ASSESSMENT OF DAM SAFETY OF COAL COMBUSTION SURFACE IMPOUNDMENTS – FINAL REPORT

**Gulf Power
Plant Scholz
Sneads, Florida**

Prepared for
*U.S. Environmental
Protection Agency
Washington, D.C.*

May 2014
Revised July 10, 2014

Title: Plant Scholz North Dike Modified (NDB-1)
Downstream, Seismic 0.072g
Method: Morgenstern-Price
Search: Grid and Radius
Optimized Critical Slip Surface: Yes
Date: 2/9/2011
By: Gallagher, Benjamin J.

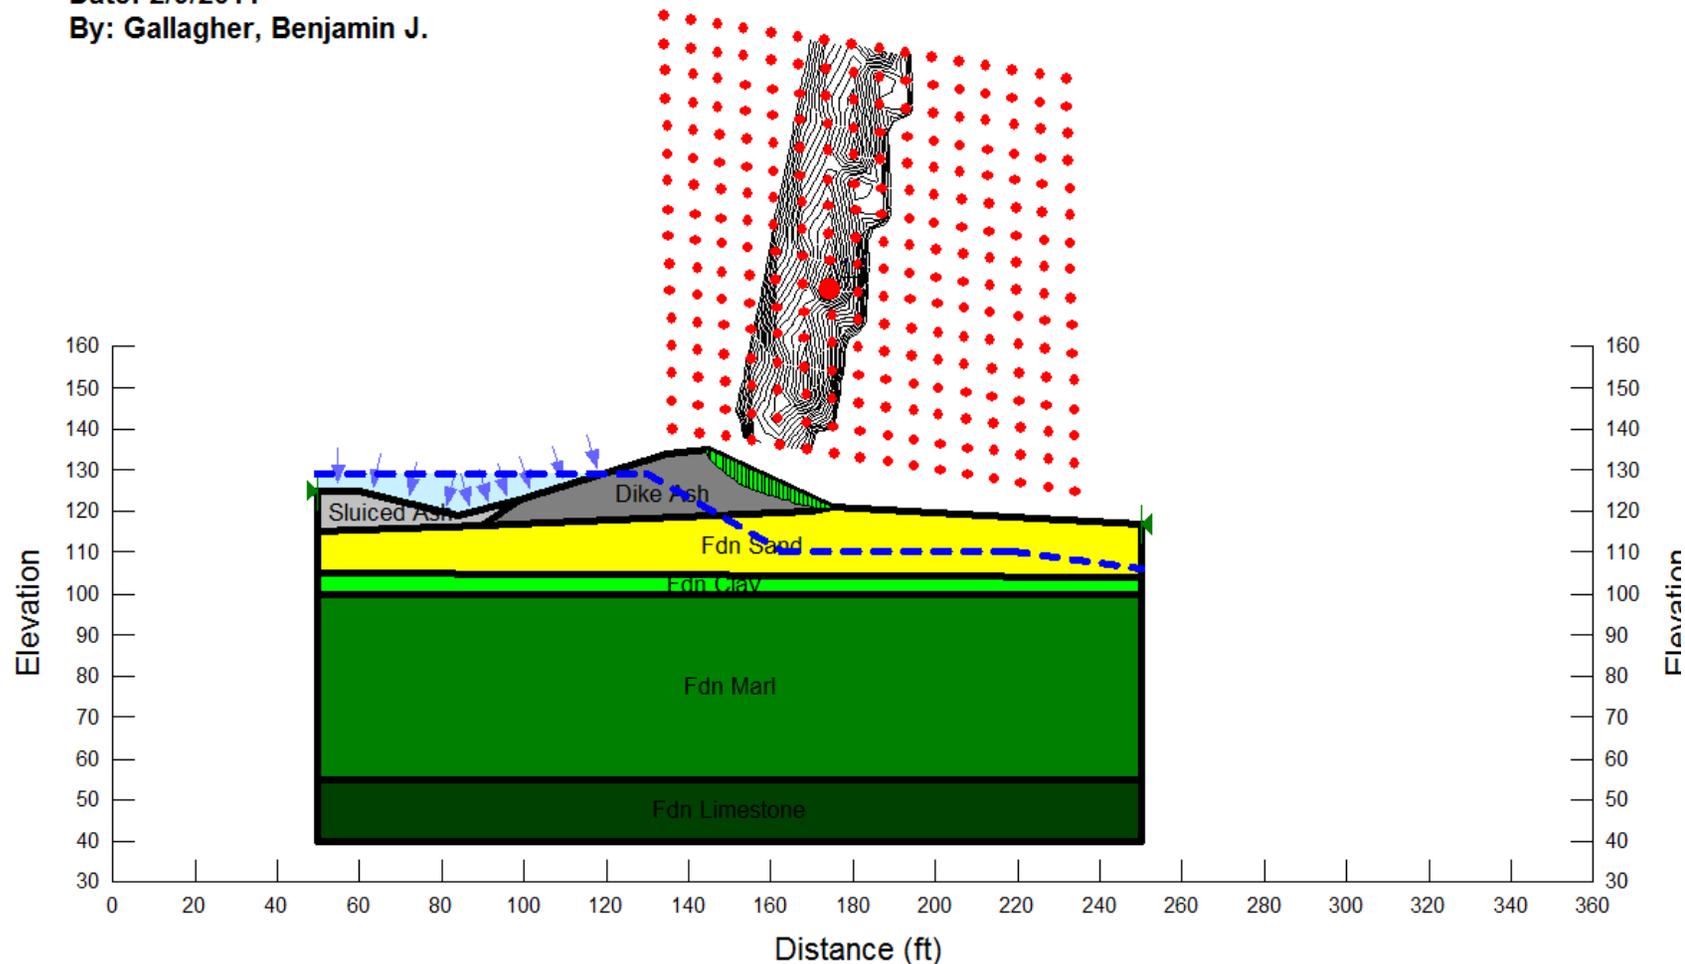
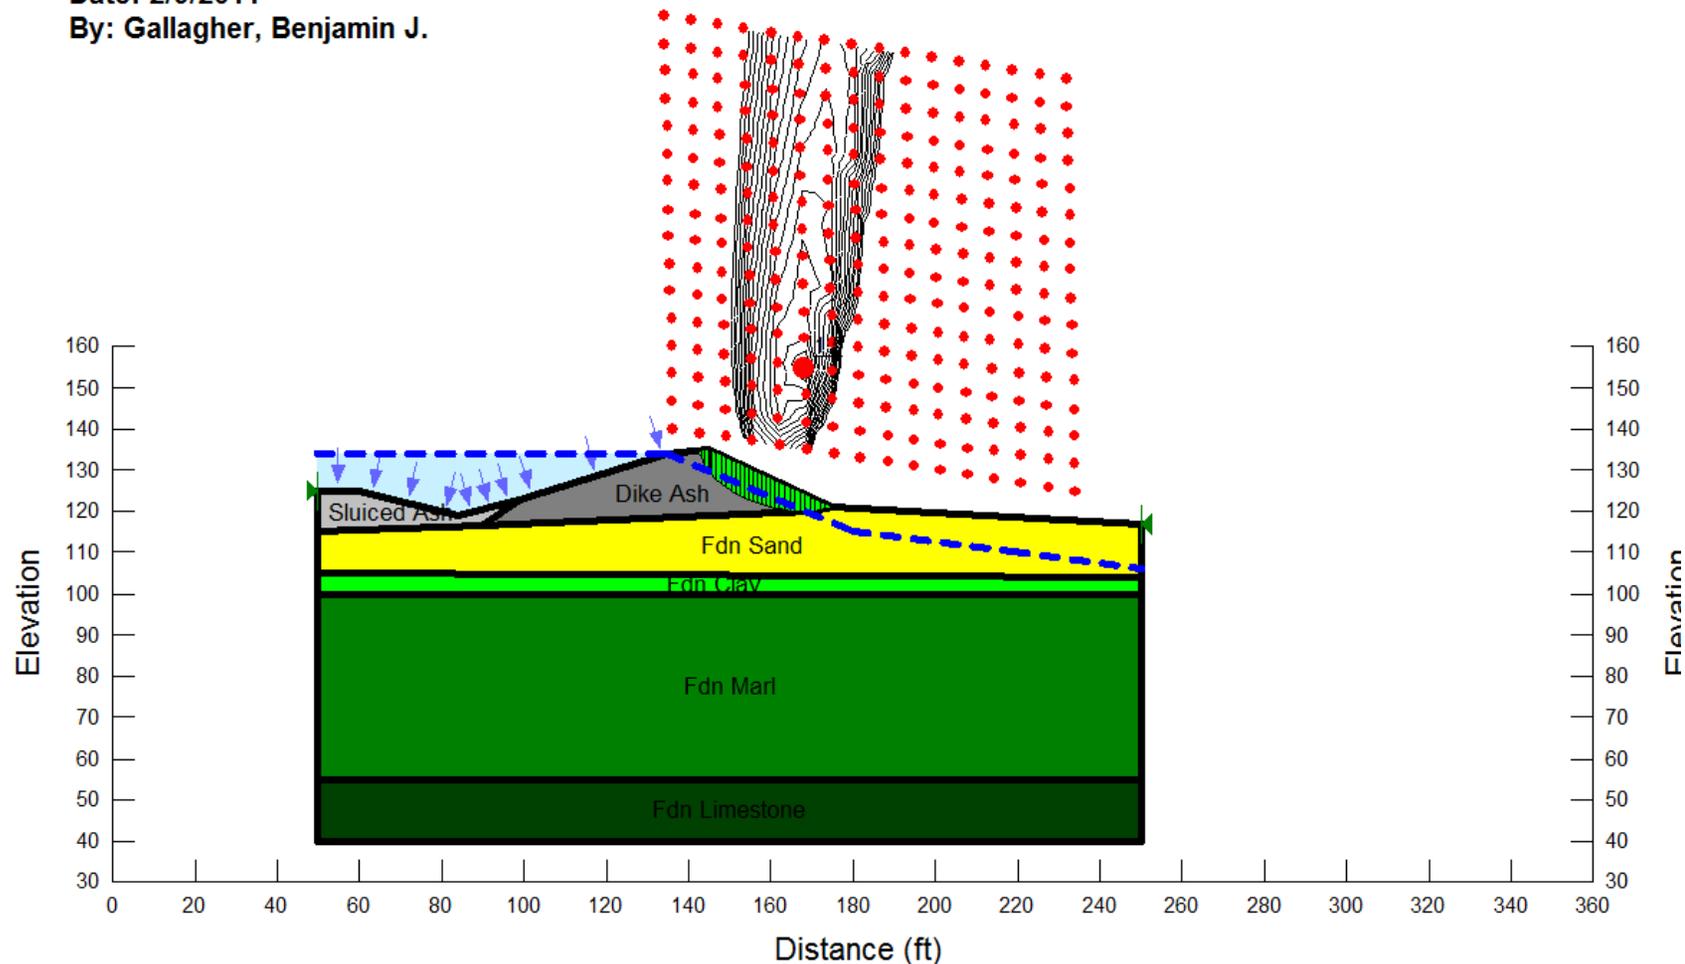
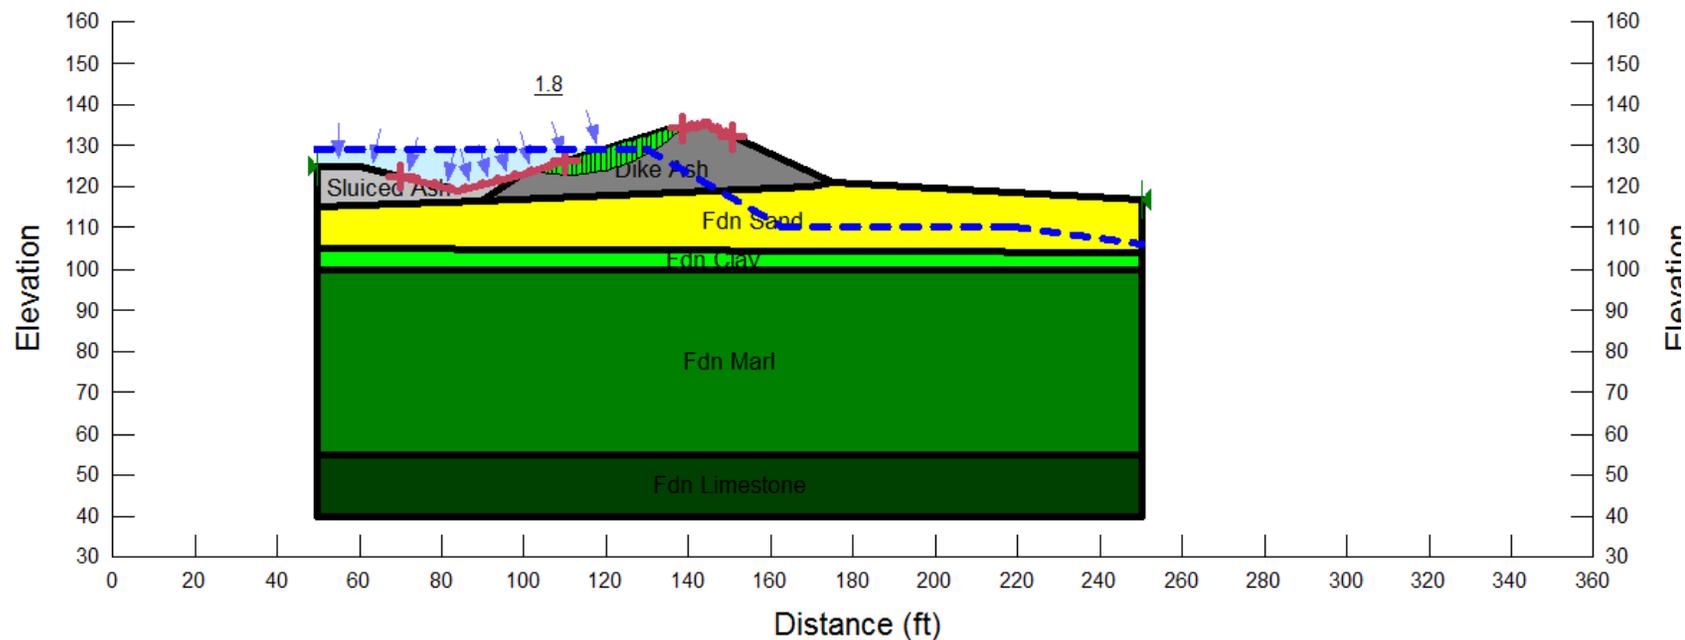
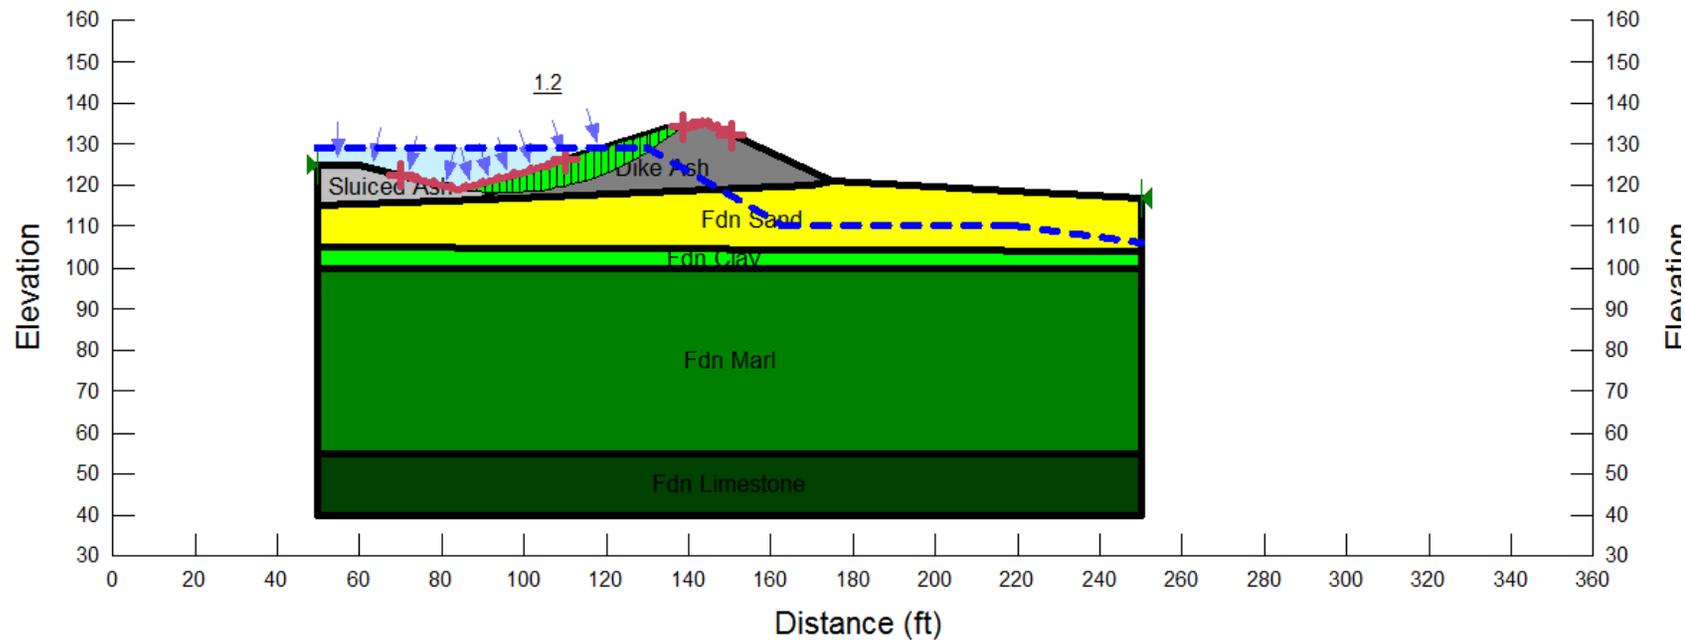
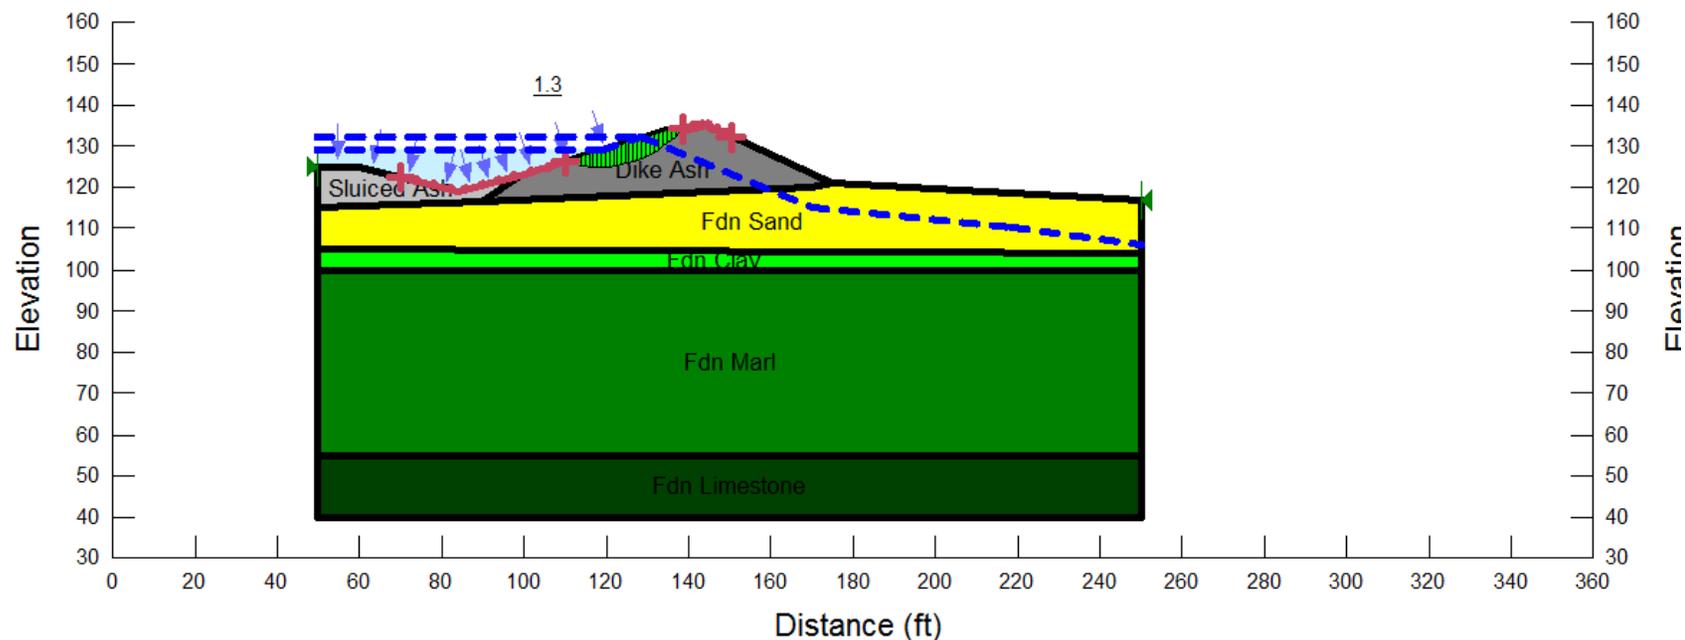
Southern Company Services February 9, 2011 report for the north and east embankments of the Upper East Pond showed a factor of safety of 1.2, under rapid drawdown loading, that did not meet the required factor of safety of 1.3. Southern Company indicates in their October 18, 2012 submittal that revised stability analyses found the upstream (interior) slopes of the pond are subject to shallow sloughing with rapid changes in water level or seismic loads. Southern Company further states the shallow depth of sloughing does not represent a hazard to the embankments, but will require prompt maintenance attention. The calculated factor of safety of 1.3 presented in Southern Company Services October 18, 2012 report for the Upper East Pond's north embankment interior slope, under the rapid drawdown case reflects acceptance by Southern Company of this condition. CDM Smith is in agreement with Southern Company Services' evaluation of the adequacy of the Upper East Pond's north and east embankments under rapid drawdown conditions, given Southern Company's commitment to prompt maintenance attention to shallow sloughing.

The stability analyses provided for the north and east embankments of the Upper East Pond and the south embankment of the Lower Pond show the required factors of safety for required loading conditions are met in all instances. Liquefaction analyses of the Upper East Pond and Lower Pond exhibit factors of safety between 0.9 and 1.4. This suggests some soft pockets may liquefy and other portions of the embankment may lose strength due to earthquake-induced pore pressure buildup. Gulf Power states in their August 22, 2012 report, they believe there is a very low likelihood of an earthquake scenario of the magnitude used for the analyses occurring over the life of Plant Scholz.
